SUBJECT: PROCUREMENT NO. 012026-1014
WEST SITCUM 11TH ST. IMPROVEMENTS

ADDENDUM NUMBER 03

WEST SITCUM TERMINAL 11TH STREET IMPROVEMENTS PROJECT ID NO. 201218.01 PURCHASE AGREEMENT # PA000000123

6724
C2.1
 SH #10 OF #15

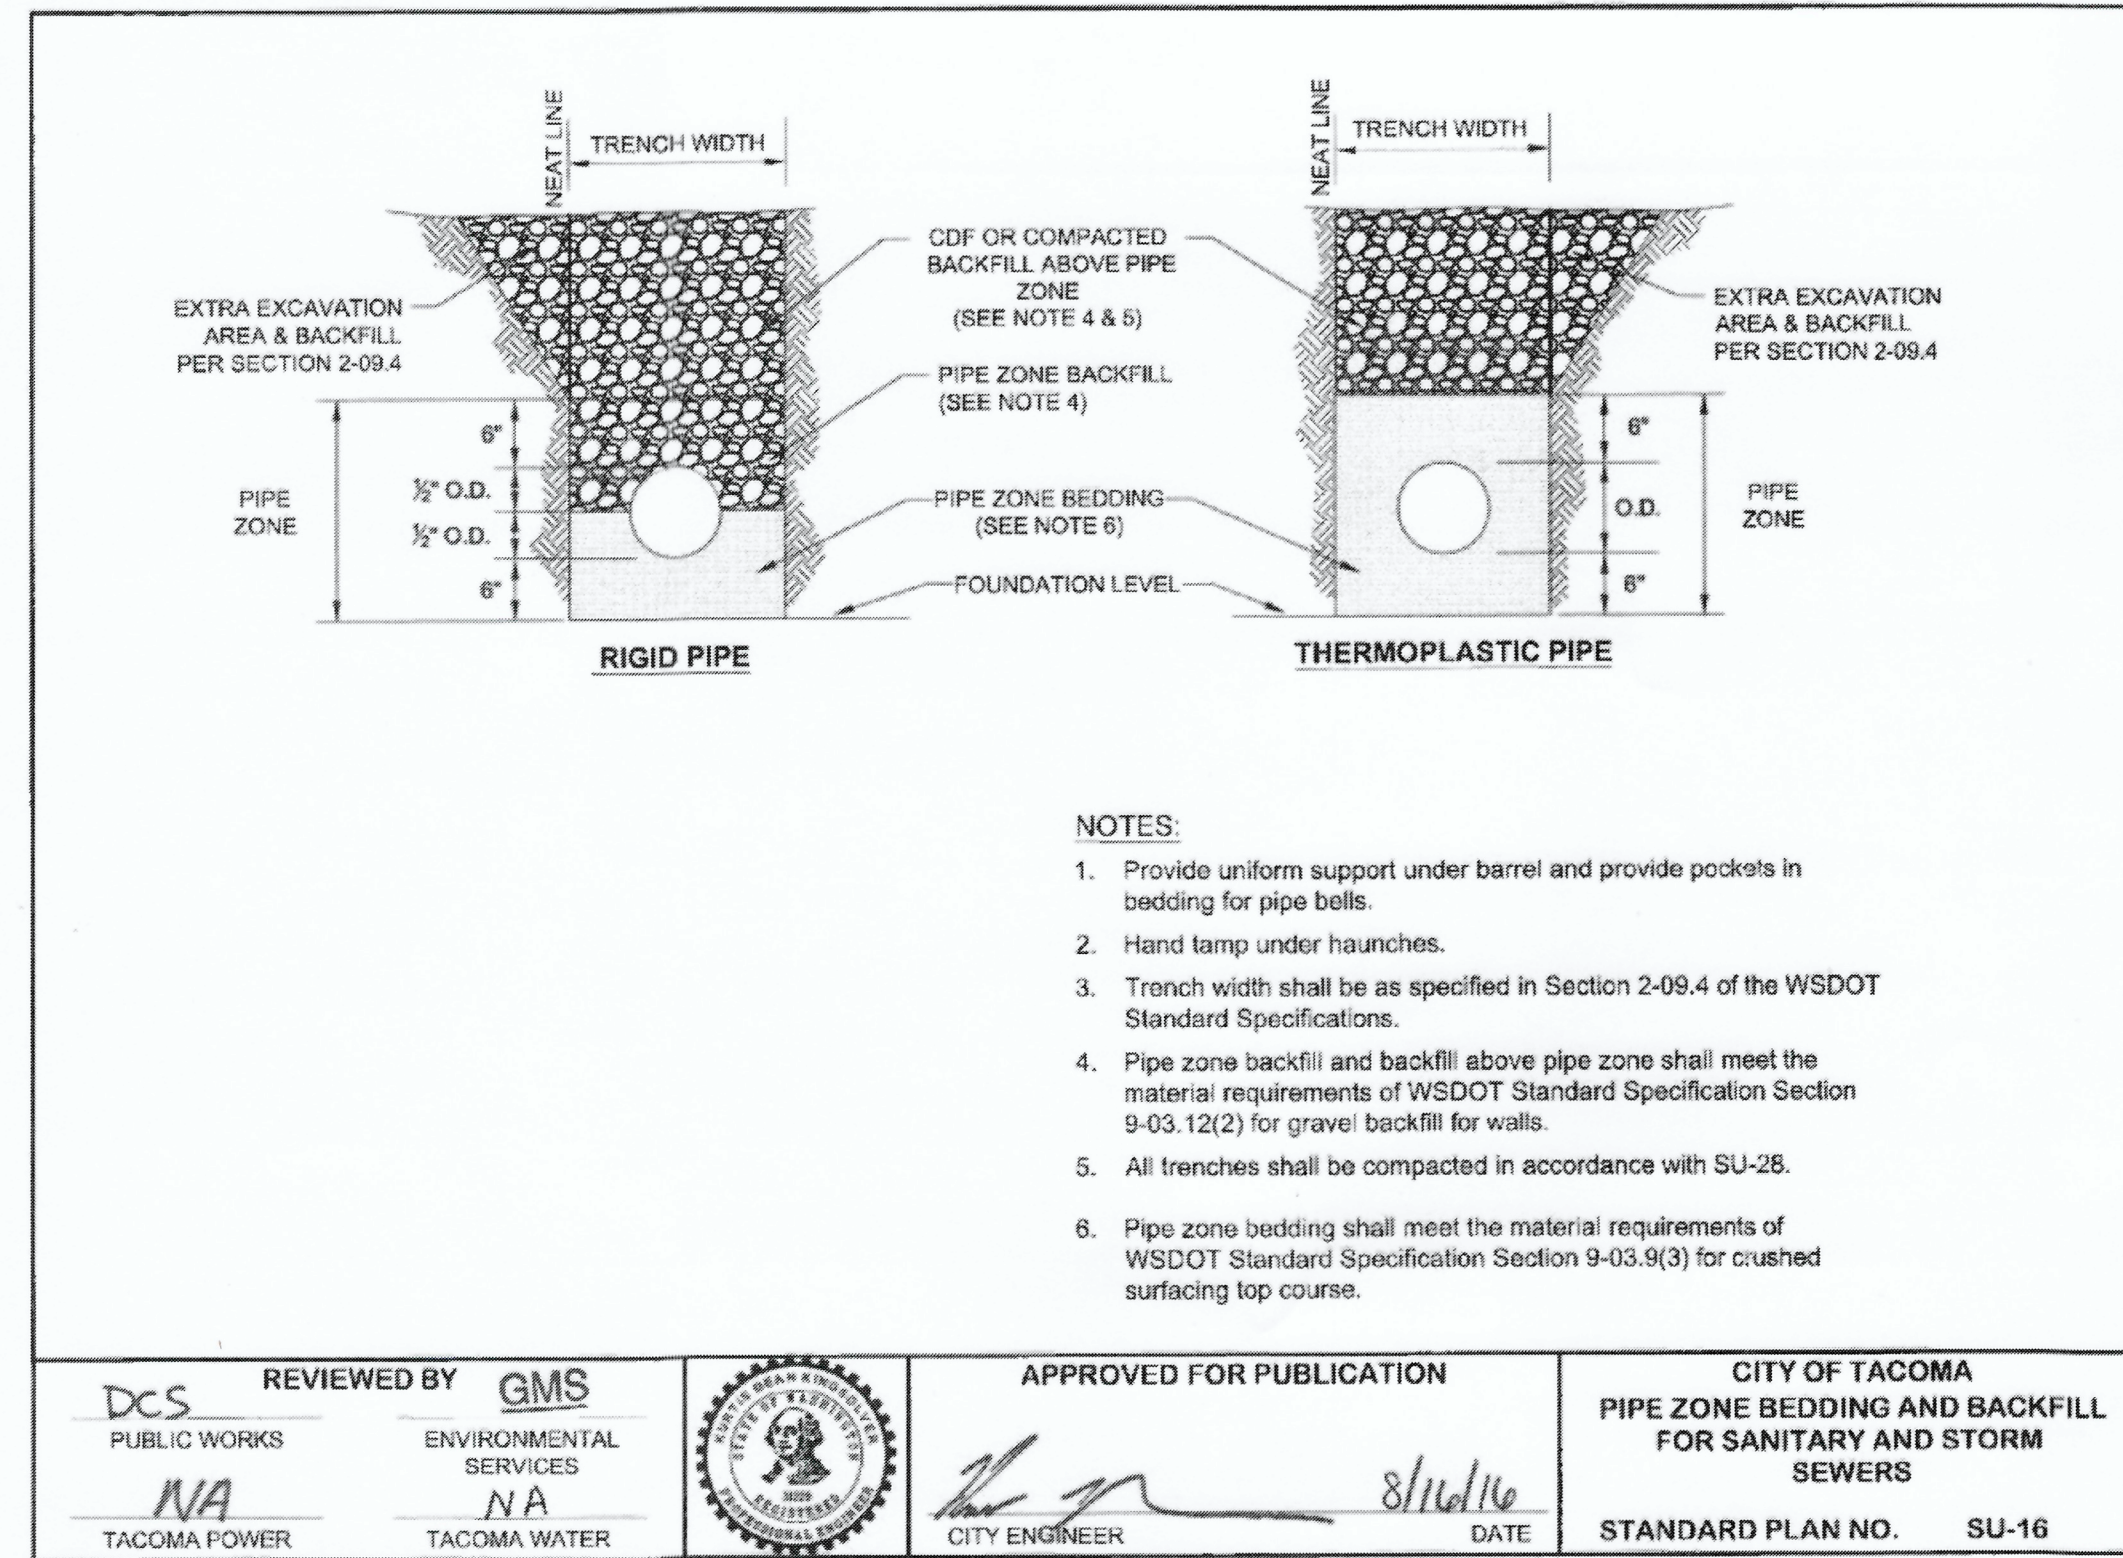
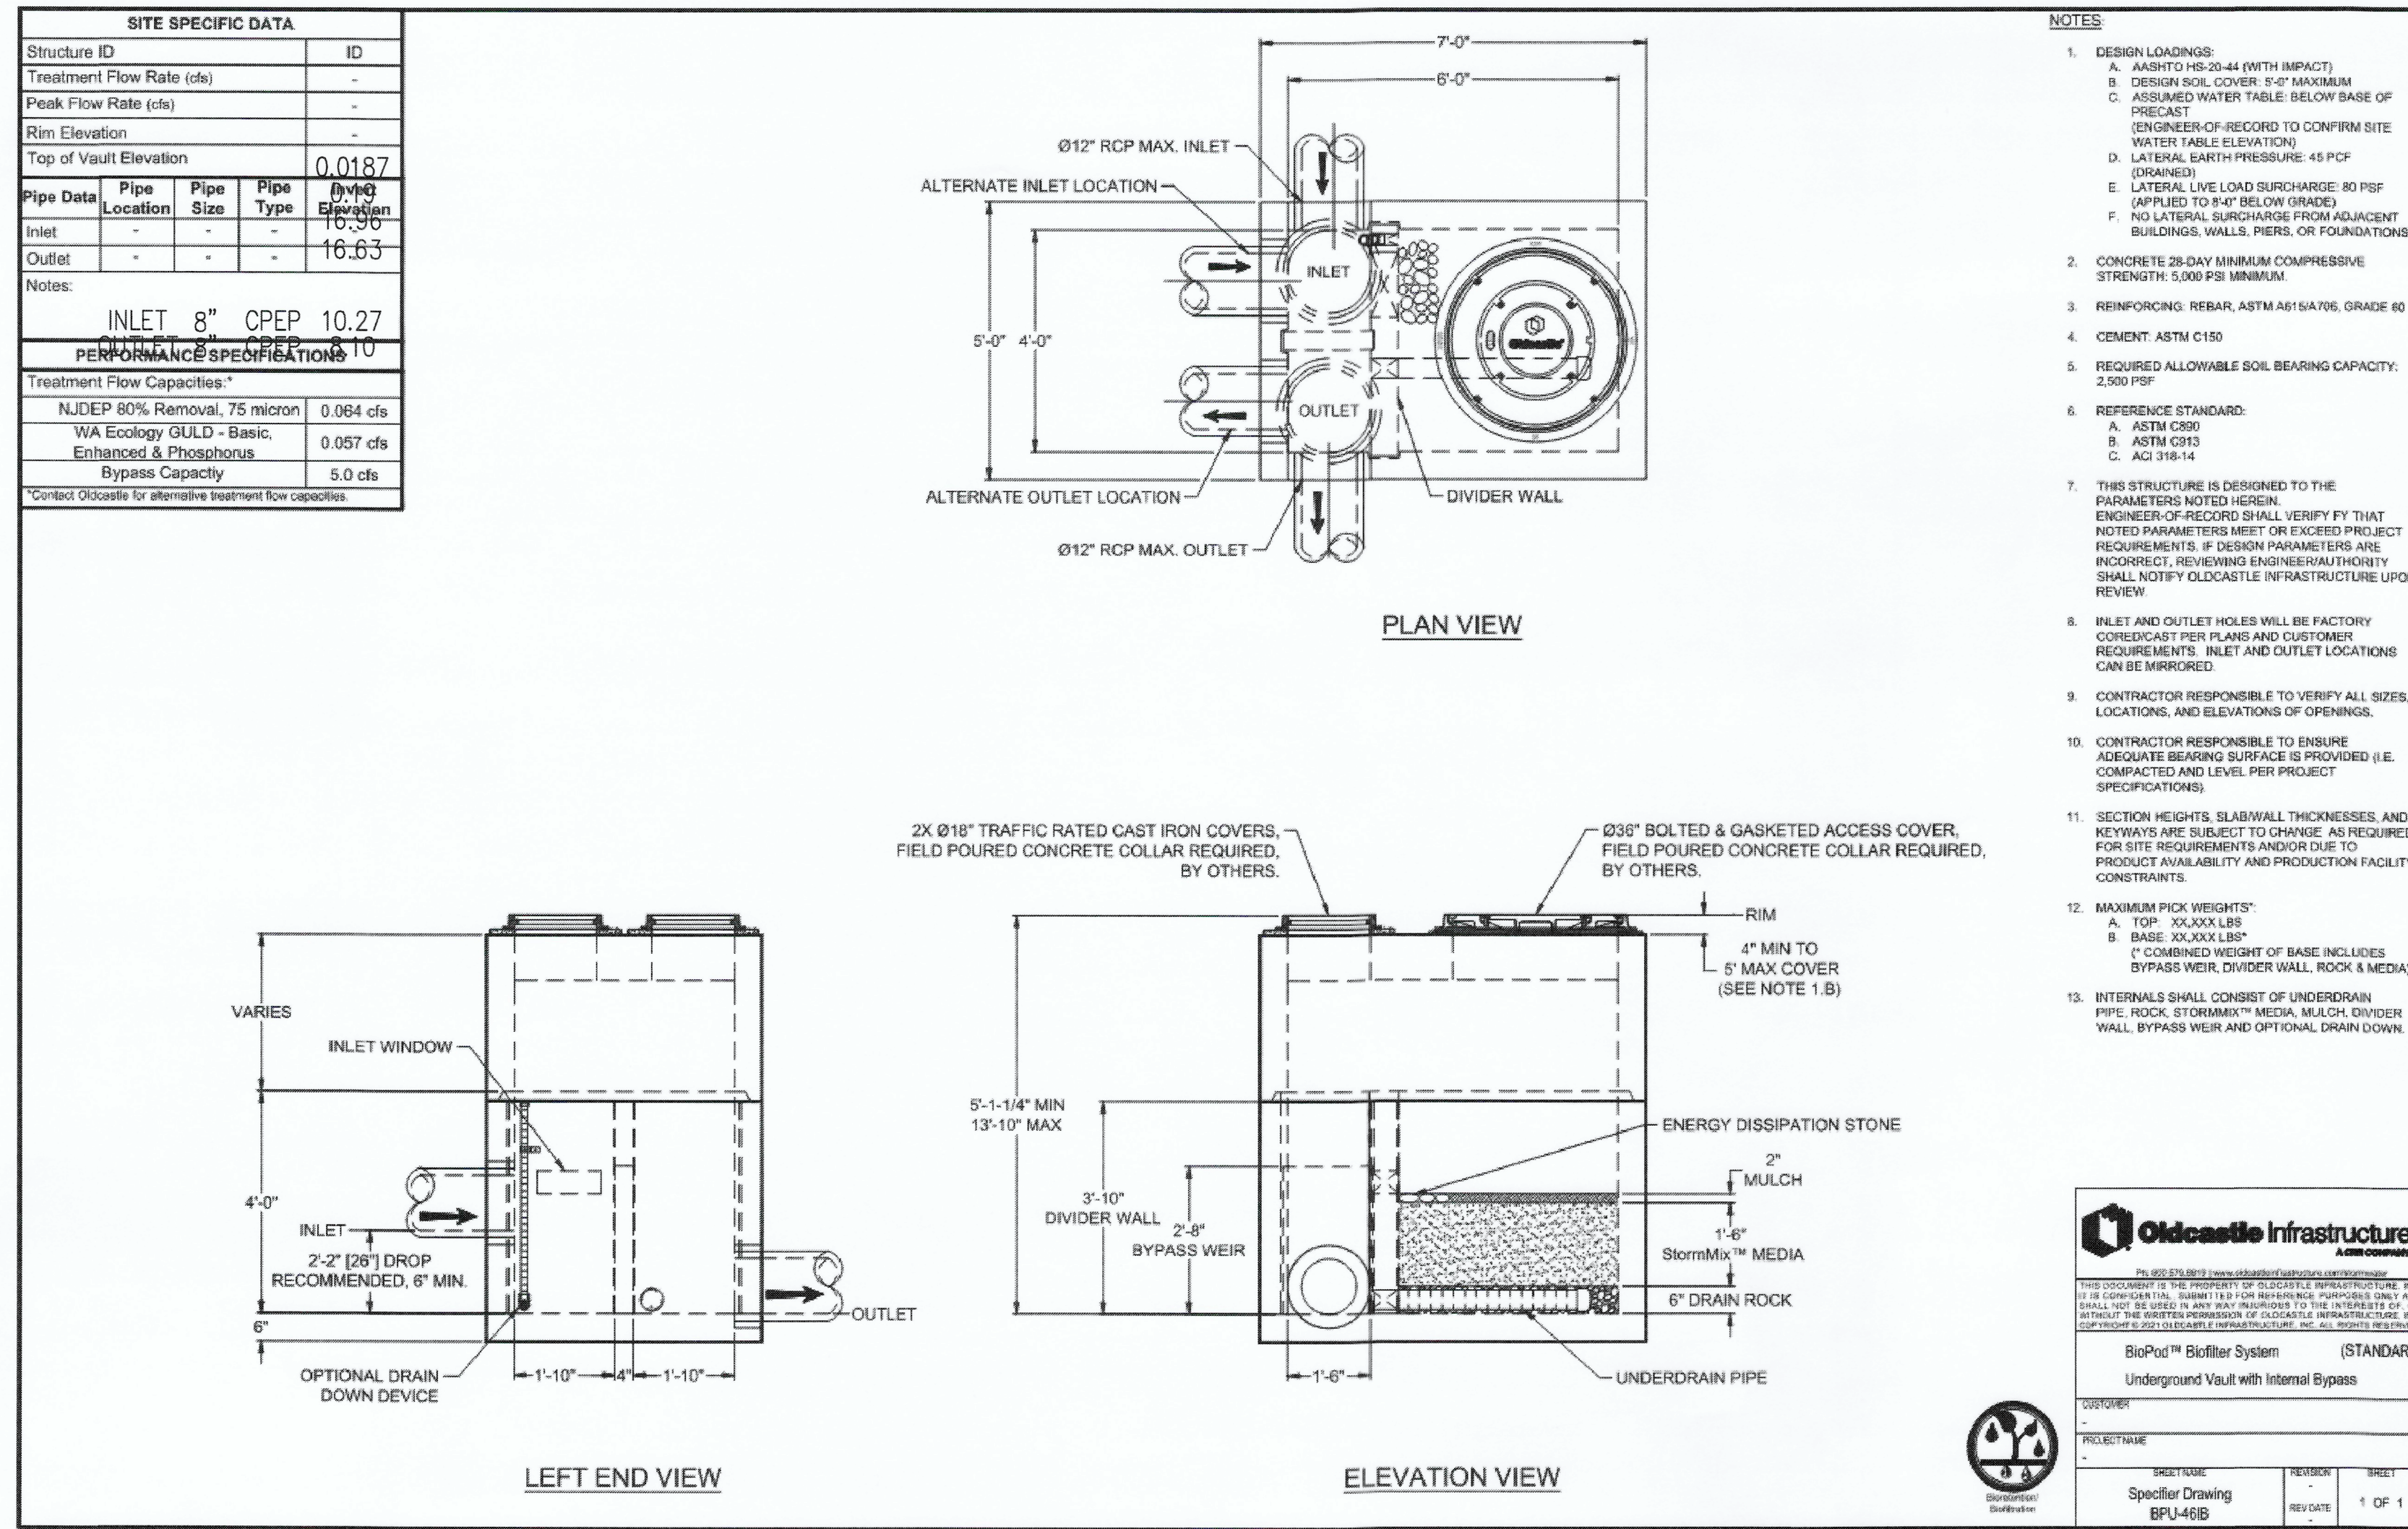
- Revised sheet title of C2.1, from 'Demolition and TESC Notes and Details' to 'Grading & Drainage Notes and Details'
